Service Bulletin

No.: MZ06-010

Model: SR4600

Subject: Correction of the Service Manual and Schematic Diagram.

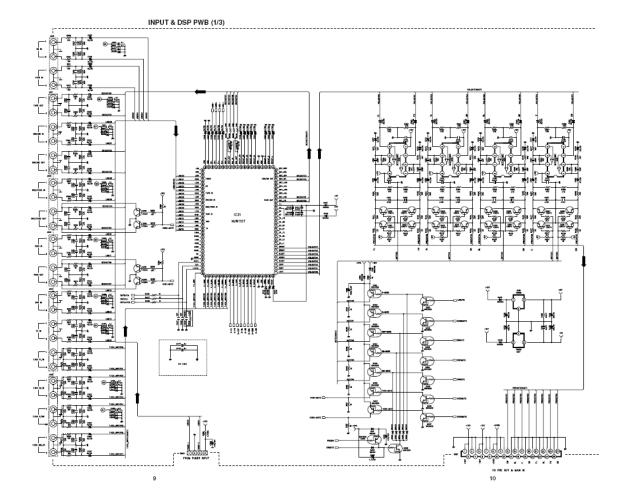
Symptom: The SCHEMATIC DIAGRAM mentioned in the SR4600's Service Manual is incorrect. (Service Manual pages 9 and 10)

Solution: SR4600 service manual (part no.90M42BW855010) INPUT & DSP PWB (1/3) schematic page 9 and 10 has been updated. See the following pages for details.
